Main Matter 4 (min 25)

Areas to be addressed Protection of Heritage Assets.

NottoScale	Drawing Title	SENSITIVE RECEPTORS AREAS
	Drawing Number	HQ/AH/AS001

Photo taken from the tower of St Marys Church zooming into St Matthias Tower.

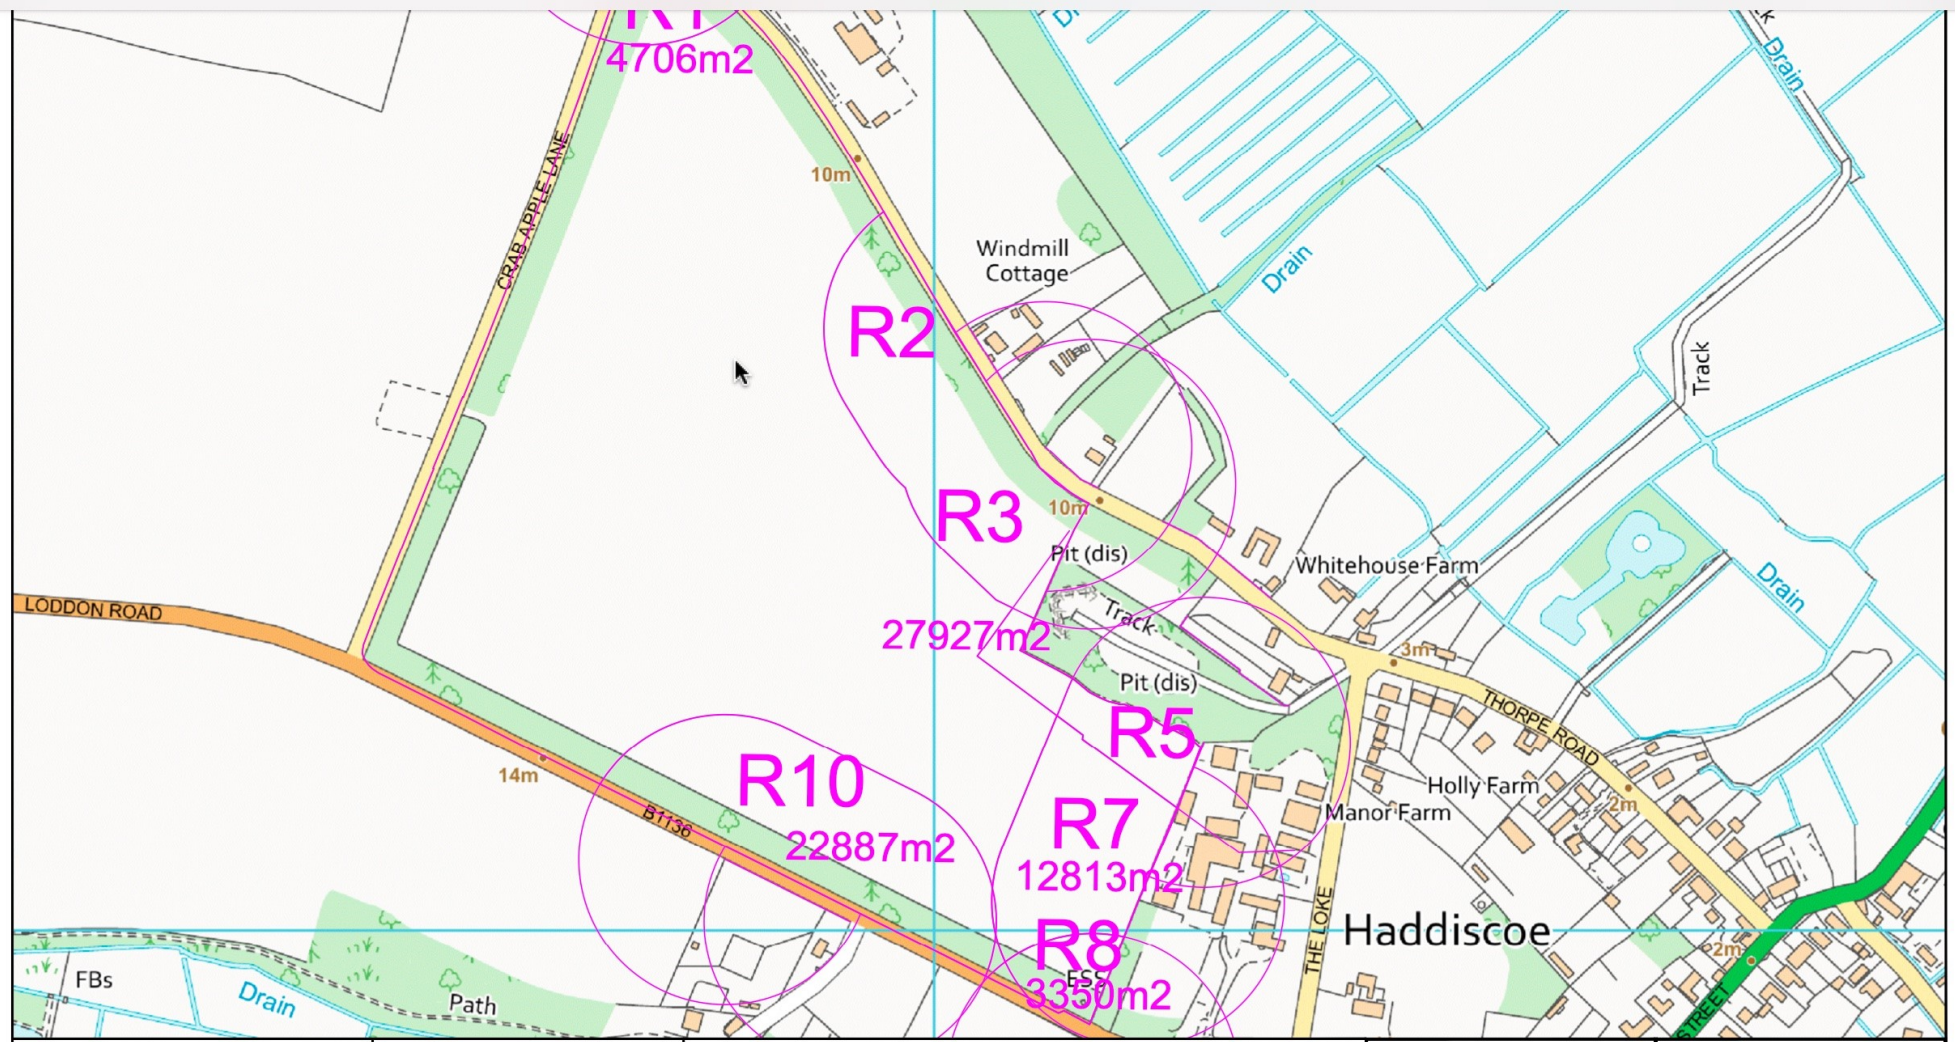
Main Matter 4: protection of Heritage Assets. Min 25 doesn't address the protection of the HLVA thus Historic Setting from the tower of St Marys Church as per the HLVA attachment produced by Stopit2, which demonstrates the visual connection to St Matthias. Its down to the discretion of the Church who can enter the church tower especially when fund raising is needed for any future vital repairs and the views from the church tower can be used to fund raise.
